Your Comment on the Milldale application

Thank you for referring the Milldale fast-track consent (Milldale Stages 4C and 10-13) to Auckland Transport for comment. Auckland Transport is a Council-Controlled Organisation and the Road Controlling Authority for the Auckland region (excluding the State Highway network). Auckland Transport has the legislated purpose to contribute to an 'effective, efficient and safe Auckland land transport system in the public interest'¹. In fulfilling this role, Auckland Transport has an interest in the Milldale Stages 4C and 10-13 fast track consent as Road Controlling Authority and as a future asset owner.

Subject: Milldale Stage 4C and Stages 10 to 13 - Fast Track Application Transport Assessment

Figure 2: Potential future bus routes and bus stop locations as discussed between Auckland Transport and the Applicant.

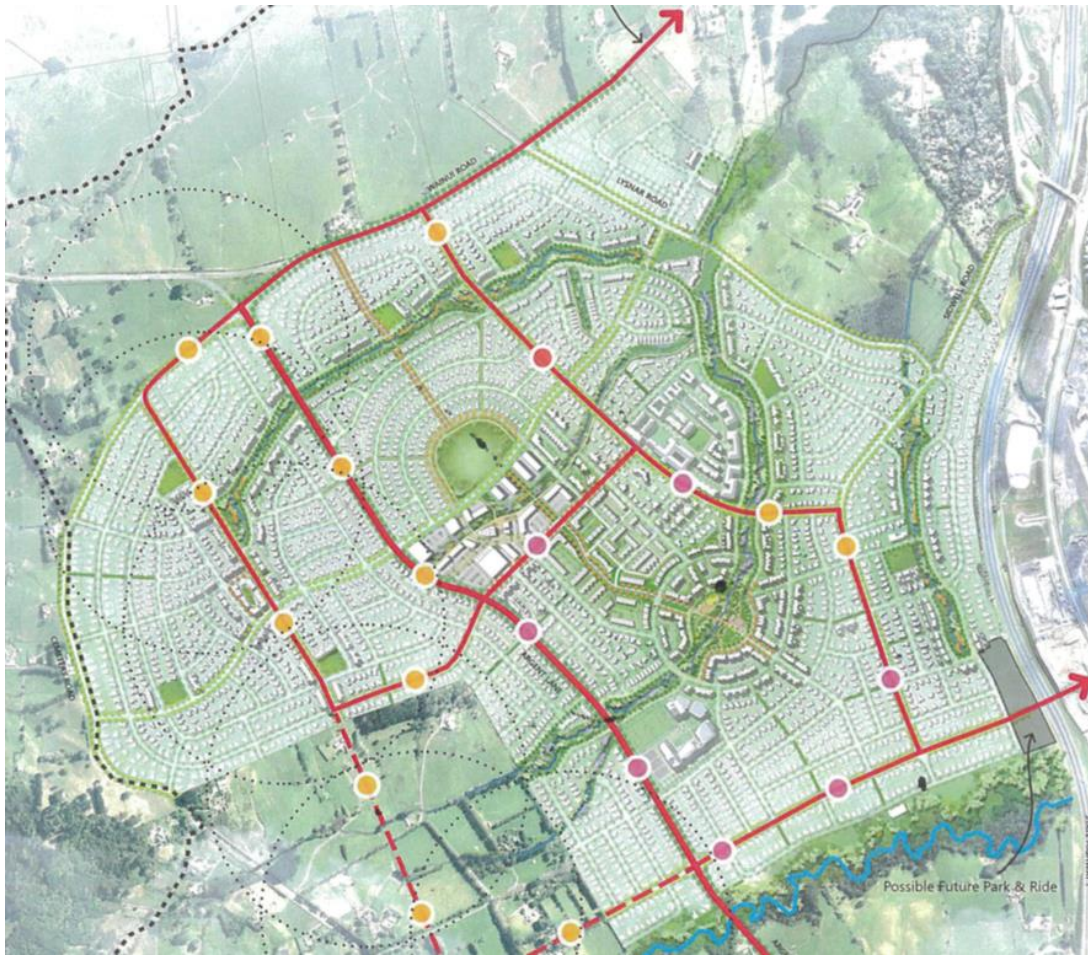
The potential future bus route, which has been discussed between the Applicant and Auckland Transport, is shown in Figure 2. It should be noted that the bus stop locations along the proposed collector roads have been suggested by the Applicant, approximately aligning with the potential future bus stop locations indicated in Figure 2. Route 989 will pass through Stages 10 to 13 of the Milldale Development, and Wainui Road shares a boundary with these stages. Therefore, as noted above, it is also required that Wainui Road be upgraded before the dwellings are occupied so that residents can access public transport.

Figure 3: Eng drawing P24-128-00-2080-RD, showing five recreational bridges highlighted.

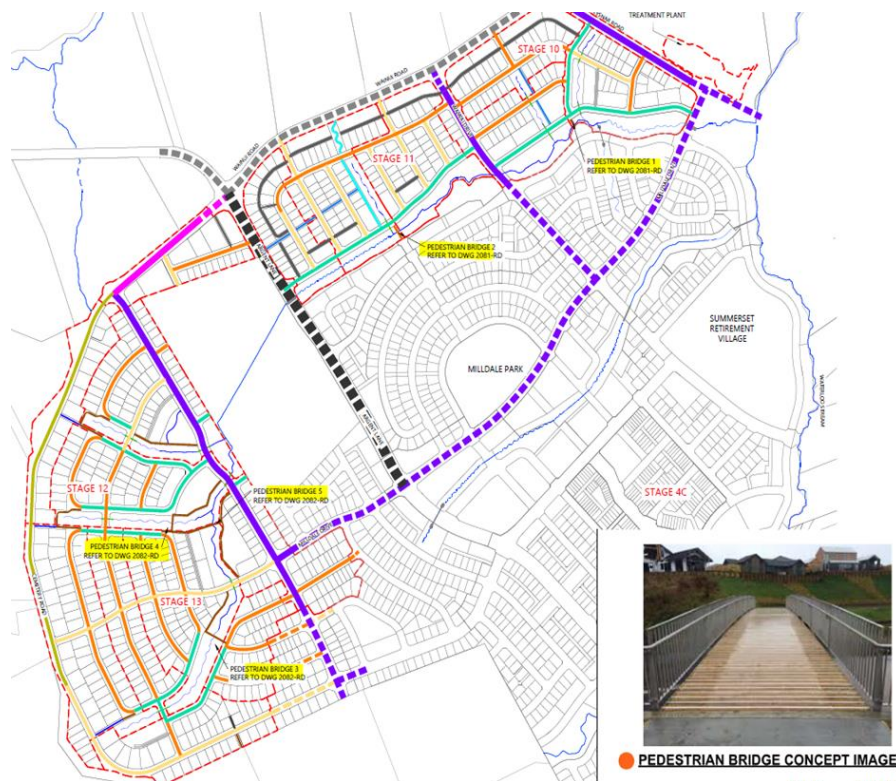
Auckland Transport has reviewed the bridges and has expressed openness to accepting Bridges 2, 3, and 4 as assets, as they can be considered road-to-road bridges serving a transport function, subject to the following conditions:

- The Applicant must ensure that the bridges and their interfaces are designed in accordance with the Transport Design Manual (TDM); and
- For any bridges with a dual function (e.g., Bridge 4, which includes a stormwater pipe), the responsibility for maintaining the utility must be clearly defined.

Auckland Council's Parks Planning team has confirmed that Bridge 1 will be accepted as a park's asset. Auckland Transport's has reviewed Bridge 5 and noted that it is not considered to have a road-to-road transport function. Therefore, Auckland Transport will not accept Bridge 5 as an asset.

Figure 2: Excerpt from the Woods Civil Drawings showing T-intersections with side roads in close proximity to each other on Collector Road CR01

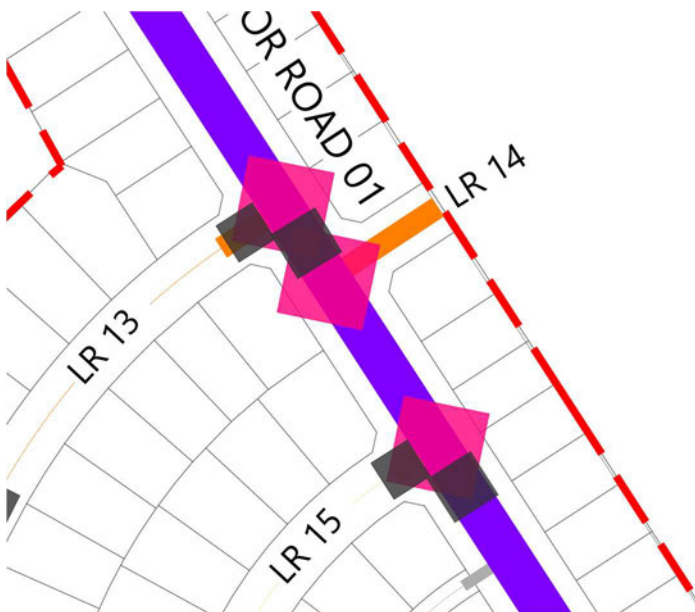
A similar concern exists on Collector Road 01 in Stage 12, where T-intersections are located too closely. Auckland Transport suggests relocating the eastern intersection one lot south to improve spacing and reduce potential conflicts.

19. A similar concern with intersection spacing also exists on Collector Road 01 in Stage 12 where T-intersections with side roads are also similarly closely spaced (refer Figure 2).

Figure 3: Excerpt from Mott McDonald Drawing 422554-MMD-00-XX-DR-C-0203-Rev A showing the upgrade works for the intersection of Pine Valley Road and Dairy Flat Highway.

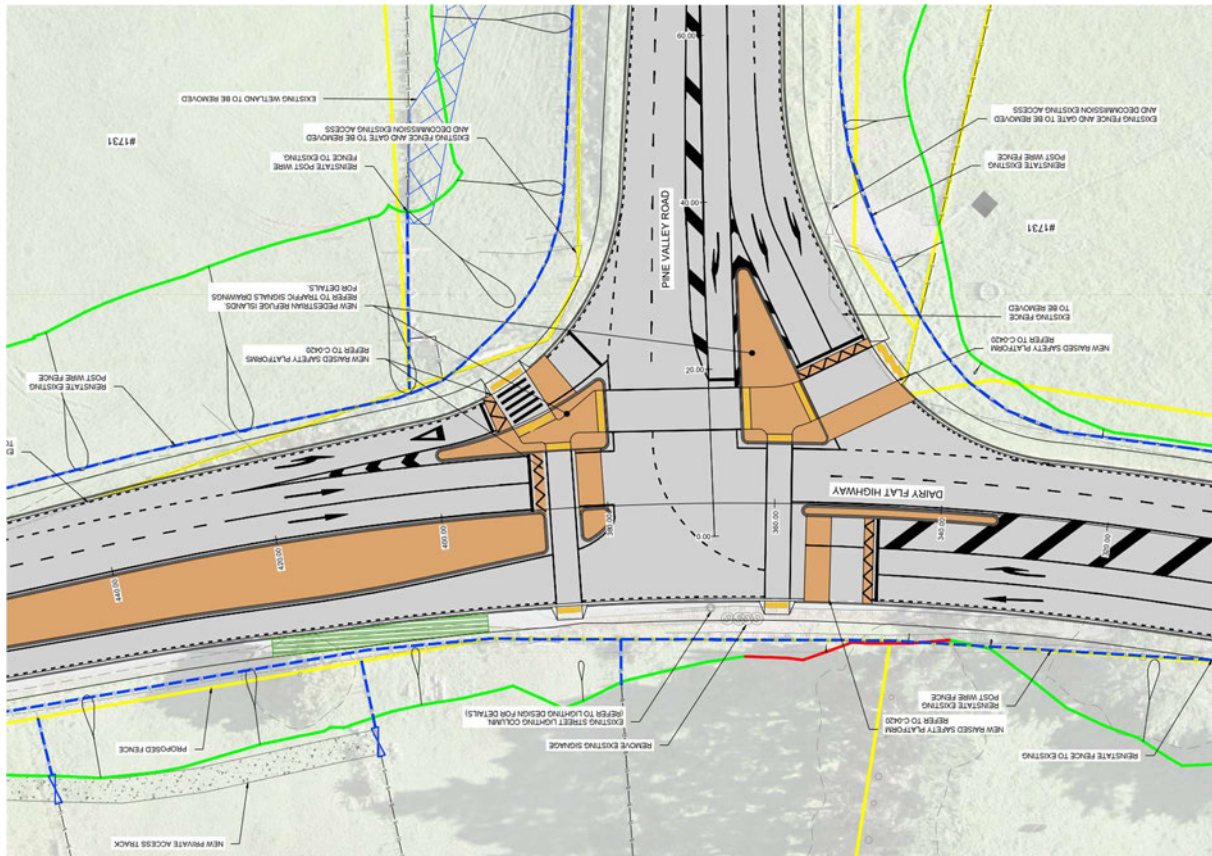
25. The drawings provided show the works in plan view only. No typical cross-sections, long-sections, or data showing existing or finished levels has been provided. Aside from chainage lines no dimensions are shown on the drawings. No vehicle tracking, traffic signal phasing, or sight distance check drawings have been supplied. I cannot confirm whether the design is appropriate or in accordance with applicable engineering guidance and standards in regard to these matters. My comments in this memorandum are limited to the intersection and details which are apparent from the drawings.

26. The Mott McDonald Drawing shows raised safety platforms (speed tables) across the slip lanes and also the through lanes on Dairy Flat Highway. According to Auckland Transport Practice Note 02 Use of raised devices on the AT Network raised safety platforms require a departure from standards when used on arterial roads. The practice note was issued after the date the drawings were produced, and I recommend confirming that the departure has been sought.

28. No footpaths or cycle facilities are shown at the intersection, but earthworks 'tad pole' indicators show that the grass berm area on either side will be shaped to facilitate future construction of these facilities on Pine Valley Road, but not Dairy Flat Highway. Mott McDonald Drawing 422554-MMD-00-XX-DR-C-0205 contains annotations indicating that the grass berms on Pine Valley Road will be future proofed for footpaths and cycleways.

29. The Mott McDonald drawing set shows two eastbound lanes on Dairy Flat Highway between Pine Valley Road and the Silverdale Motorway Interchange.
30. In October 2023 NZTA lodged 13 notices of requirement (NoR) with Auckland Council for route protection.

Figure 4: NoR8 drawings for the intersection of Dairy Flat Highway and Milldale Road.

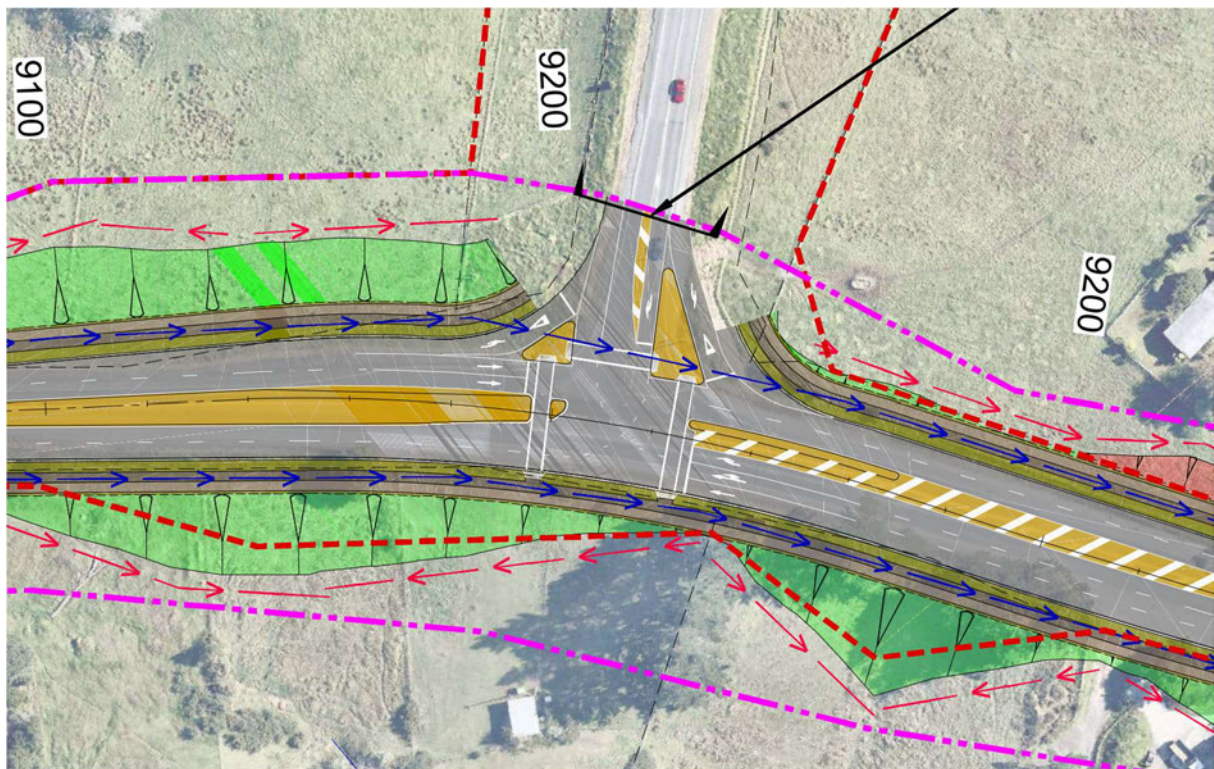
33. The principal differences between the two drawings are that compared to the Mott McDonald drawing the NoR8 drawing has only one lane for the left turn out of Pine Valley Road, no raised safety platforms are shown on the NoR8 drawing, no pedestrian crossing facilities are shown for the slip lanes, pedestrian and cyclist paths are shown on Dairy

Flat Highway, there is an extra westbound departure lane on Dairy Flat Highway west of the intersection and an extra shared right and through approach lane for Dairy Flat Highway east of the intersection.
